Exhibit 3: Lunt-Fontanne Theater

Exhibit 3B: Architectural Modifications

Exh. 3B Architectural Modifications to Lunt Fontanne Theater

Exhibit 3A: Entrances

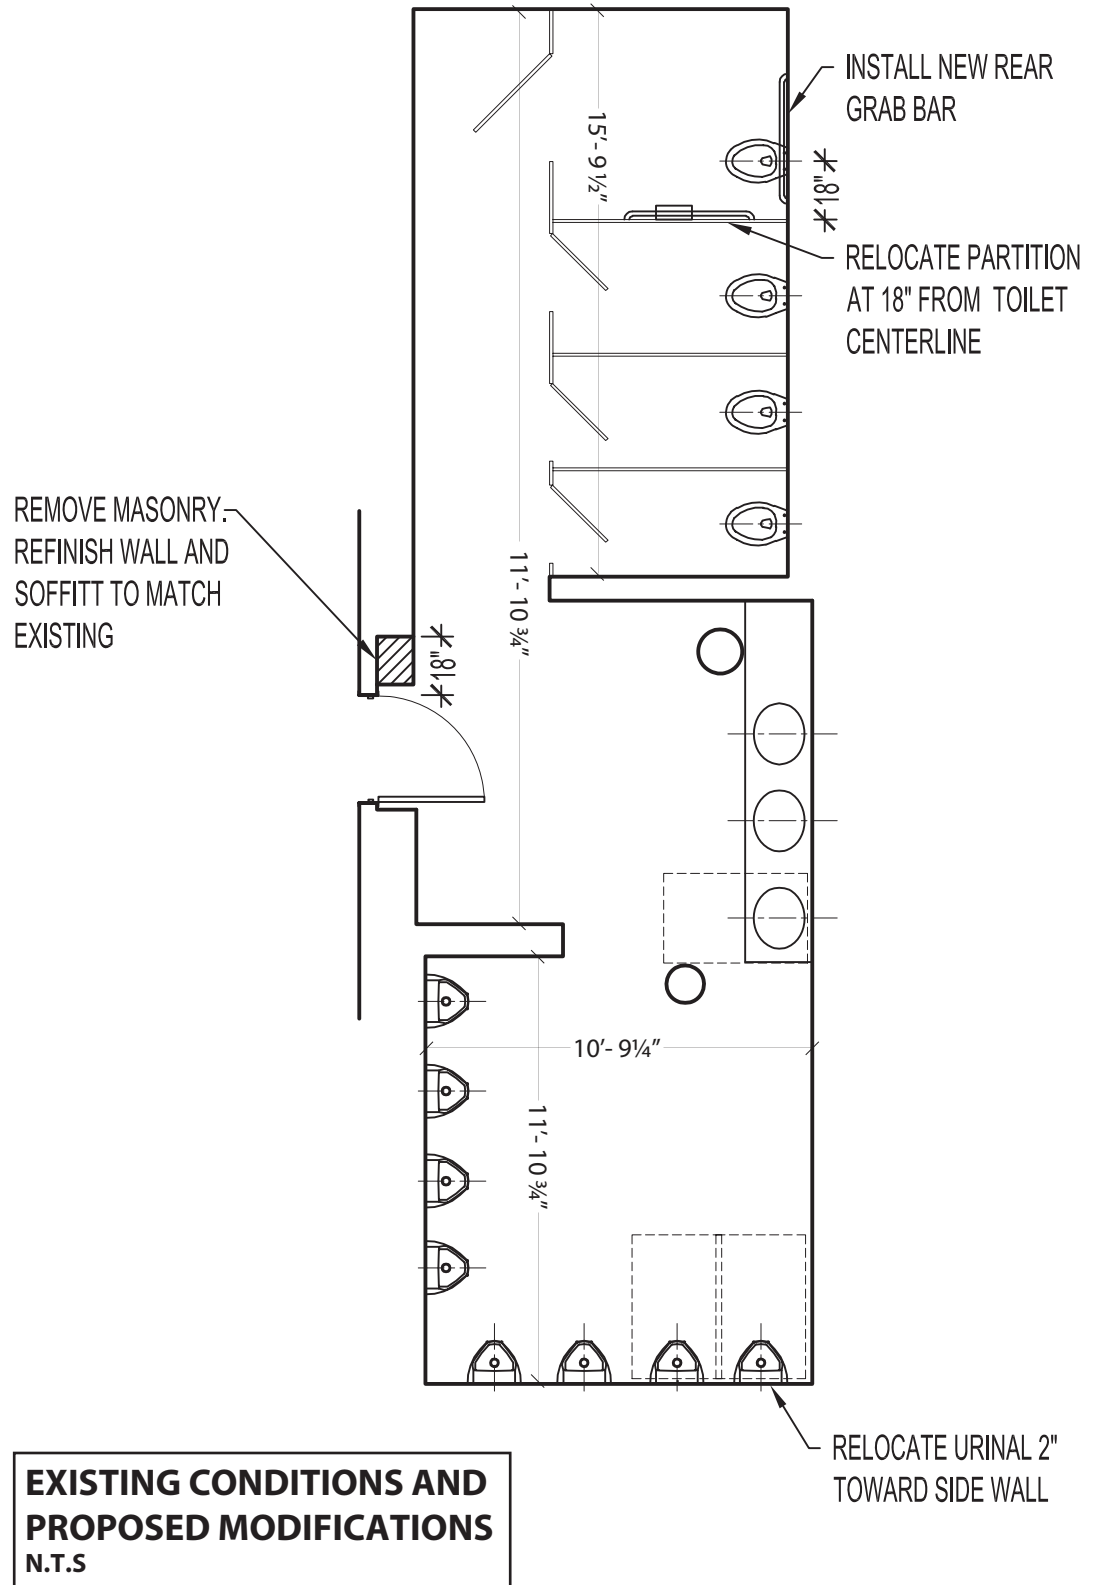
Nederlander shall install automatic doors at the second set of double doors from the interior ticket window. Nederlander may also, at its option, maintain the automatic doors at the fourth set of double doors from the interior ticket window, in same condition as set forth on Exhibit 3A (i.e., in the same condition as they existed for the Government's inspection conducted on May 3, 2011). Nederlander shall adopt queuing and line management procedures to ensure that a person with mobility impairments shall have a means of entry into the foyer of the Theater, and access to the interior ticket window.

3. LUNT FONTANNE THEATER LOWER LEVEL MEN TOILET ROOM PLAN

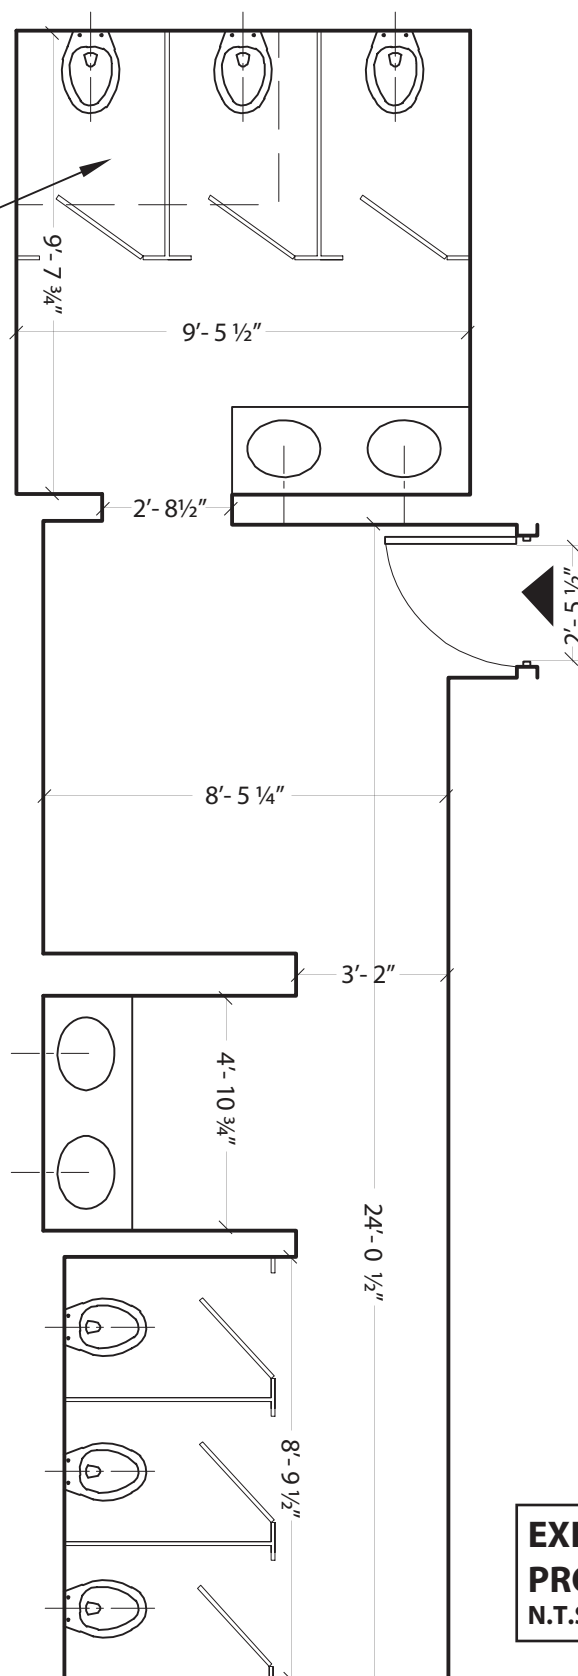
MODIFY PARTITION
TO OBTAIN
AMBULATORY STALL
(OUT-SWINGING
DOOR, GRAB BARS
BOTH SIDE)

21	Lower Level (Men's Toilet Room)	The door is located in an alcove 11" deep with 3" width maneuvering clearance on the pull side of the door.	Maneuvering clearance at doorway is less than required.	4.1.3(7)(b) 4.1.3(7)(c) 4.1.3(7)(d) 4.13.6 Fig. 25(a-f)	Defendant will modify doorway to provide compliant maneuvering clearance.
22	Lower Level (Men's Toilet Room)	There are 4 lavatories with 32" rim height with no knee space provided.	The counter mounted lavatory provides less than the required knee clearance (29" minimum AFF at front, 27" minimum AFF at 8" deep).	4.1.3(11) 4.19.2 4.19.3 4.22.6 Fig. 31	Compliant lavatory has been provided during course of investigation.

Line #	Location Description	Existing Condition	Barrier Description	1991 Standards Reference	Architectural Modification
23	Lower Level (Men's Toilet Room)	The toilet paper dispenser is mounted 32" to the near edge from the rear wall and 42" to the far edge from the rear wall.	The toilet paper dispenser in the standard accessible stall is mounted more than 36" from the rear wall.	4.1.3(11) 4.1.6(1)(b) 4.1.6(2) 4.16.6 4.22.4 4.22.7 Fig. 29(b) Fig. 30(d)	Compliant toilet dispenser mounting location has been provided during course of investigation.
24	Lower Level (Men's Toilet Room)	There is no rear grab bar in the accessible stall.	There is no rear grab bar in the accessible stall.	4.1.3(11) 4.1.6(1)(b) 4.1.6(1)(c) 4.1.6(1)(k)(ii) 4.1.6(2) 4.17.6 4.22.4 Fig. 29 Fig. 30(a,a-1)	Defendant will provide compliant rear grab bar.
25	Lower Level (Men's Toilet Room)	There is no coat hook in the accessible toilet stall although one of the three non-accessible stalls has a coat hook.	There is no coat hook in the accessible toilet stall.	36.202(b) 4.1.3(11) 4.2.5 4.2.6 4.22.7 4.25 4.27.3 Fig. 5 Fig. 6 Fig.38	Compliant coat hook mounting height has been provided during course of investigation.

3. LUNT FONTANNE THEATER UPPER LEVEL WOMEN TOILET ROOM PLAN

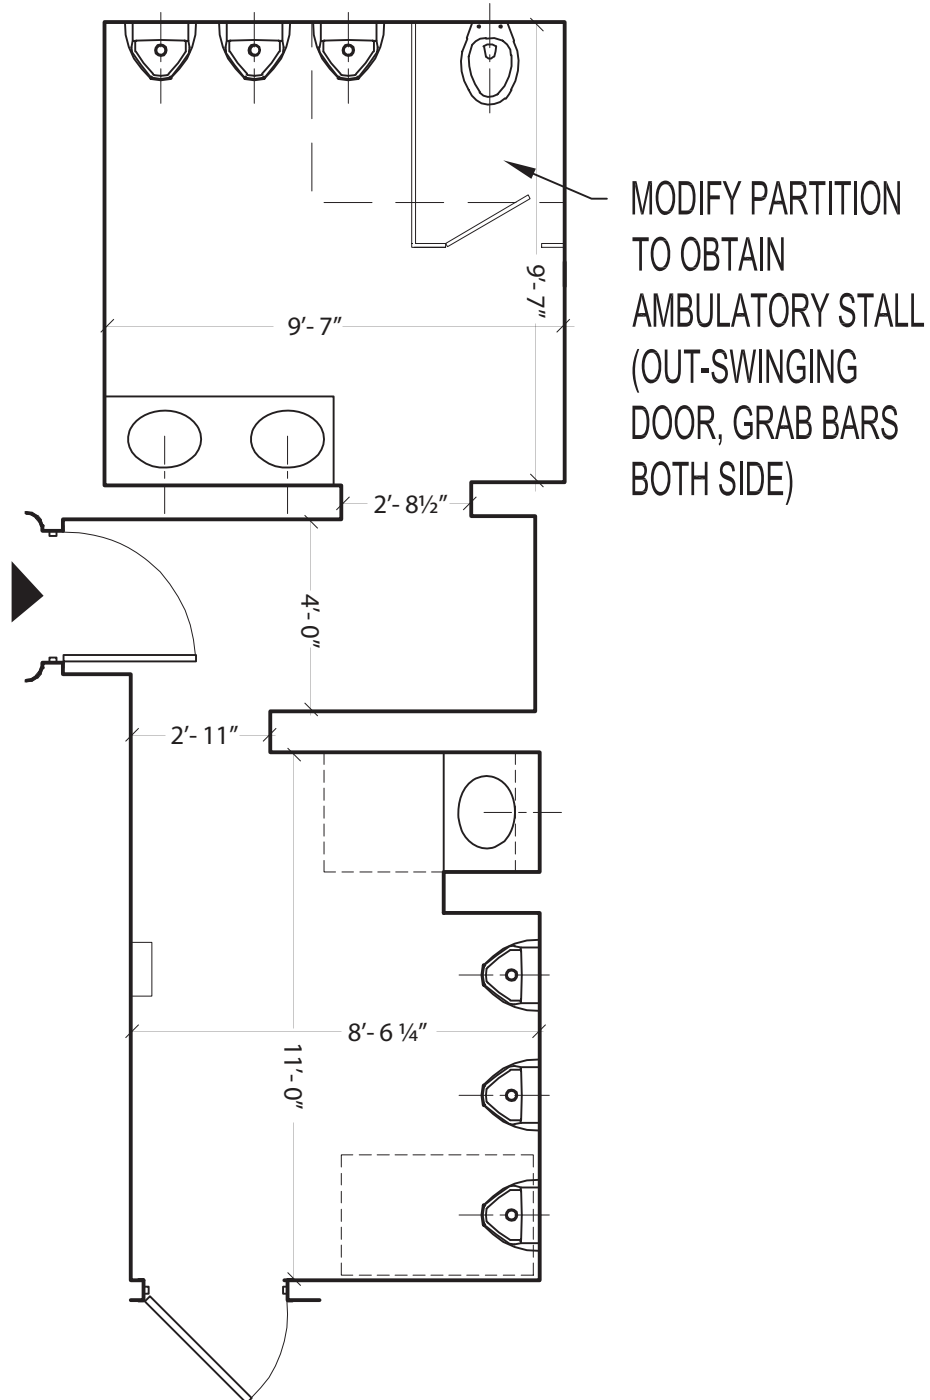
42	Upper Level (Women's Toilet Room)	The threshold is 1½" high.	Existing threshold is greater than ¾" high.	4.1.3(7)(b) 4.1.3(7)(c) 4.1.3(7)(d) 4.1.6(3)(d)(ii)	Compliant threshold has been provided during course of investigation.
43	Upper Level (Women's Toilet Room)	The 4 lavatory countertop is 33" AFF with no knee space provided.	The counter mounted lavatory provides less than the required knee clearance (29" minimum AFF at front, 27" minimum AFF at 8" deep).	4.1.3(11) 4.19.2 4.19.3 4.22.6 Fig. 31	Compliant lavatory has been provided during course of investigation.
44	Upper Level (Women's Toilet Room)	There is no ambulatory stall (for little people and those who use certain types of mobility assistance devices) and no standard accessible stall for wheelchair users.	There are 6 stalls in this toilet room, none of which are accessible.	4.1.3(11) 4.1.6(b) 4.1.6(c) 4.1.6(1)(k)(ii) 4.1.6(2) 4.1.6(3)(e) 4.17 4.22.4	Defendant will provide an ambulatory stall.

3. LUNT FONTANNE THEATER UPPER LEVEL MEN TOILET ROOM PLAN

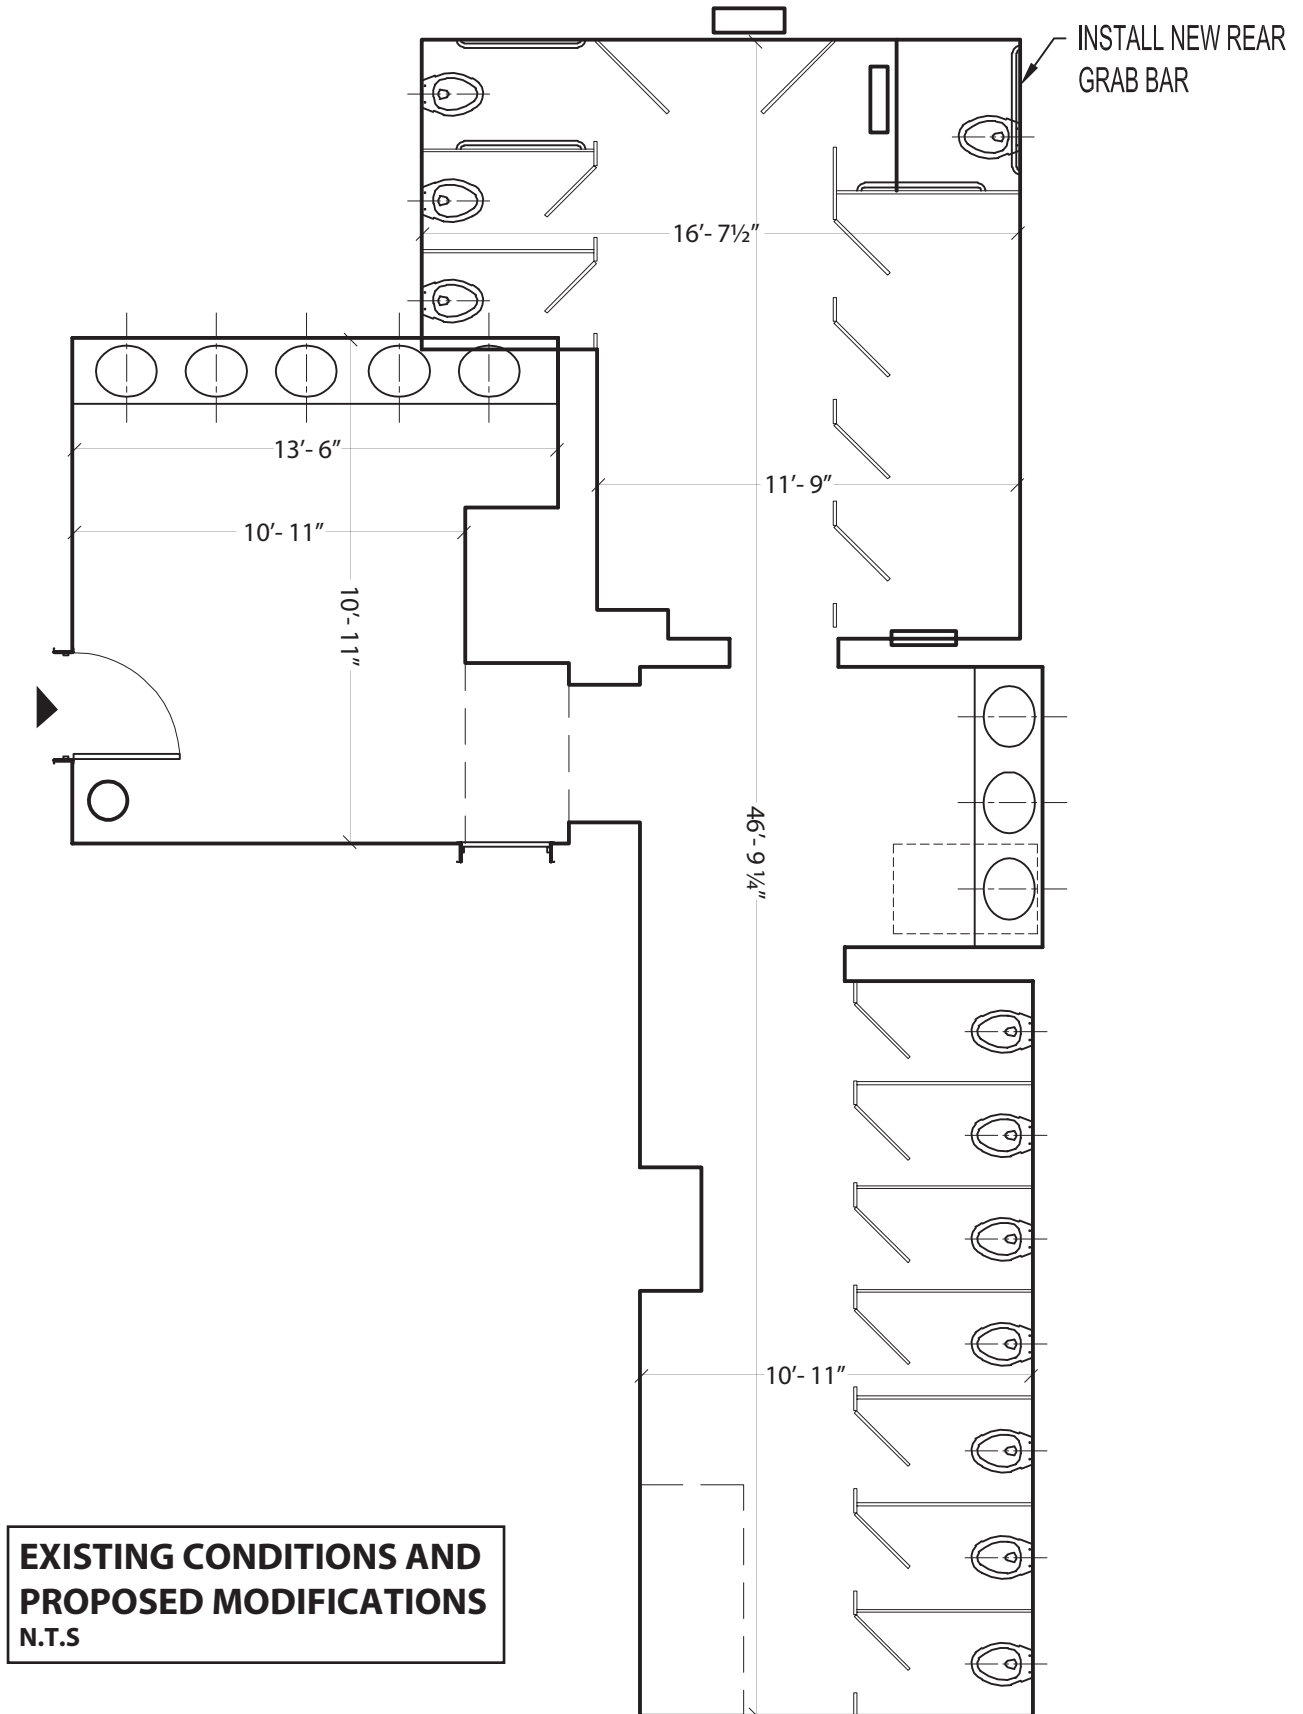
36	Upper Level (Men's Toilet Room)	Overhead sign but no compliant raised lettering and Braille sign provided.	There is no raised lettering and Braille room identification sign provided at this gender specific multi- user toilet room.	4.1.3(16)(a) 4.30.1 4.30.4 4.30.5 4.30.6	Compliant signage has been provided during course of investigation.
37	Upper Level (Men's Toilet Room)	The threshold is 1¼" high.	Existing threshold is greater than ¾" high.	4.1.3(7)(b) 4.1.3(7)(c) 4.1.3(7)(d) 4.1.6(3)(d)(ii) 4.13.8 4.5.2 Fig. 7(c,d)	Defendant will lower threshold to a compliant height.
38	Upper Level (Men's Toilet Room)	There are 3 lavatories with 32" rim height without the required knee space.	The counter mounted lavatory provides less than the required knee clearance (29" minimum AFF at front, 27" minimum AFF at 8" deep).	4.1.3(11) 4.19.2 4.19.3 4.22.6 Fig. 31	A compliant lavatory has been provided during course of investigation.

Line #	Location Description	Existing Condition	Barrier Description	1991 Standards Reference	Architectural Modification
39	Upper Level (Men's Toilet Room)	There are 3 urinals in this toilet room, none of which are accessible.	There is no accessible urinal in this toilet room.	4.1.3(11) 4.22.5 4.18	An accessible urinal has been provided during course of investigation.
40	Upper Level (Men's Toilet Room)	There is 1 toilet stall in this toilet room and it is not accessible.	There is no accessible toilet stall in this toilet room.	4.1.3(11) 4.1.6(b) 4.1.6(c) 4.1.6(1)(k)(ii) 4.1.6(2) 4.1.6(3)(e) 4.17 4.22.4	Defendant will provide an ambulatory stall.
41	Upper Level (Women's Toilet Room)	Overhead sign but no compliant raised lettering and Braille sign provided.	There is no raised lettering and Braille room identification sign provided at this gender specific multi- user toilet room.	4.1.3(16)(a) 4.30.1 4.30.4 4.30.5 4.30.6	Compliant signage has been provided during course of investigation.
